Class II change

The modification of TPM-167, TC-400 (changed From TPM167, FCC ID: LJL041201T):

Model:TC-400

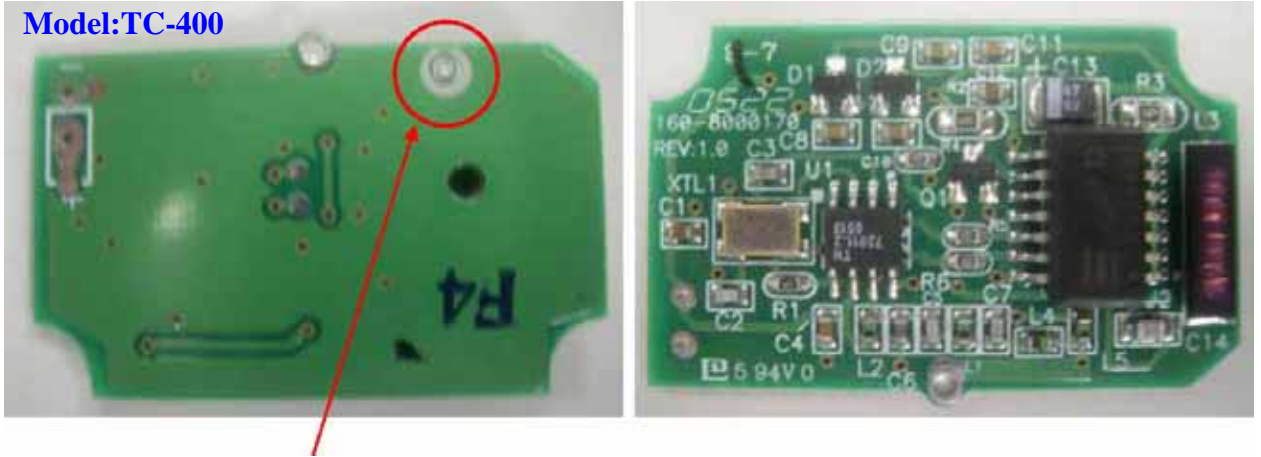
Original Display

New Edition Display
